Project	IEEE 802.16 Broadband Wireless Access Working Group <http://ieee802.org/16>		
Title	Handover - Serving BS Release with Data Forwarding		
Date	2004-05-10		
Submitted			
Source(s)	Yong-Ho Kim LG Electronics, Inc. 533,Hogye-1dong,Dongan-gu, Anyang-shi,Kyongki-do,Korea	Voice: 82-31-450-4387 Fax: 82-31-450-7912 mailto:ronnykim@lge.com	
Re:	Response to IEEE 802.16-04/19 (Recirculation Ballot #14a Announcement)		
Abstract	Handover option of Serving BS release with Data Forwarding		
Purpose	Enhance the handover performance during handover		
Notice	This document has been prepared to assist IEEE 802.16. It is offered as a basis for discussion and is not binding on the contributing individual(s) or organization(s). The material in this document is subject to change in form and content after further study. The contributor(s) reserve(s) the right to add, amend or withdraw material contained herein.		
Release	The contributor grants a free, irrevocable license to the IEEE to incorporate material contained in this contribution, and any modifications thereof, in the creation of an IEEE Standards publication; to copyright in the IEEE's name any IEEE Standards publication even though it may i

Figure E.X Example HO with Serving BS release with data forwarding

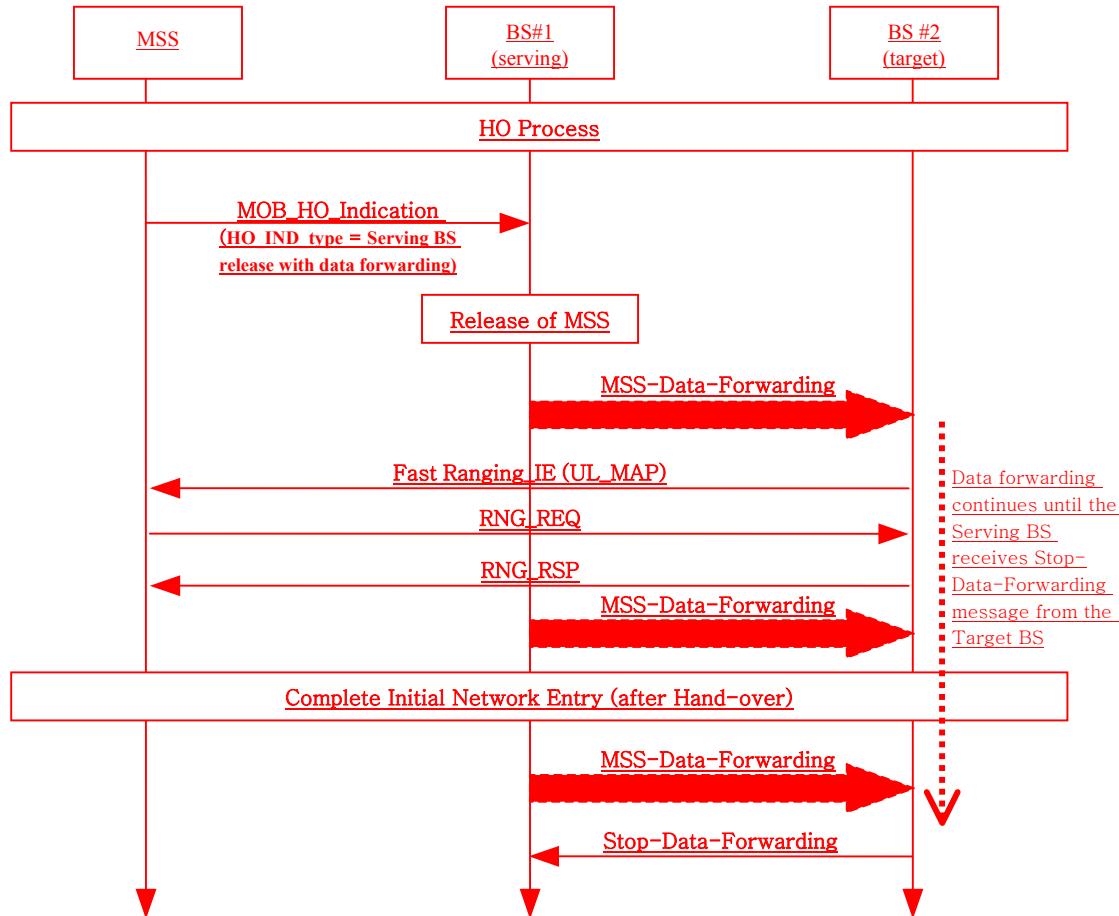
*[Add new Messages Sequence Charts for **HO_IND_type** of Serving BS release with data forwarding:
appropriate allocation of numbering is required.]*
